TECHNICAL BULLETIN 017

April 2017

H90 AND H100/112 FLEXIBLE COUPLING FOR NHD AND NMT SERIES

Current Flexible Couplings NMT Series

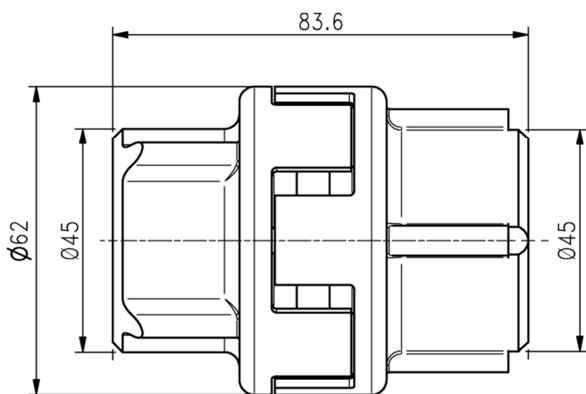
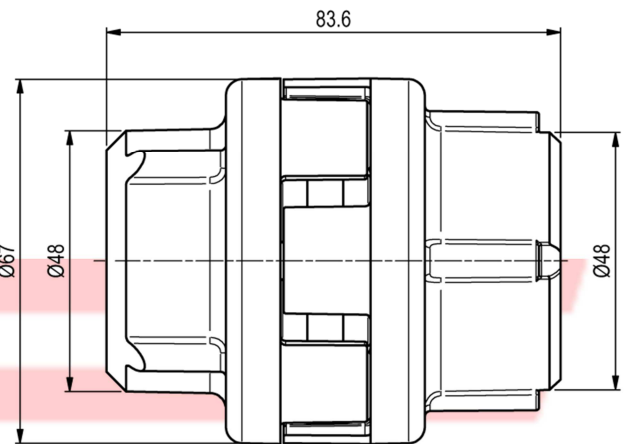
- Flexible couplings for NHD and NMT series have updated. They have been enlarged and reinforced.
- New versions are interchangeable with old ones, even in combination with current motor flanges.
- Part numbers are still the same: 1.099-542.0 and 1.099-543.0 for NHD series, 1.099-541.0 and 1.099-544.0 for NMT series
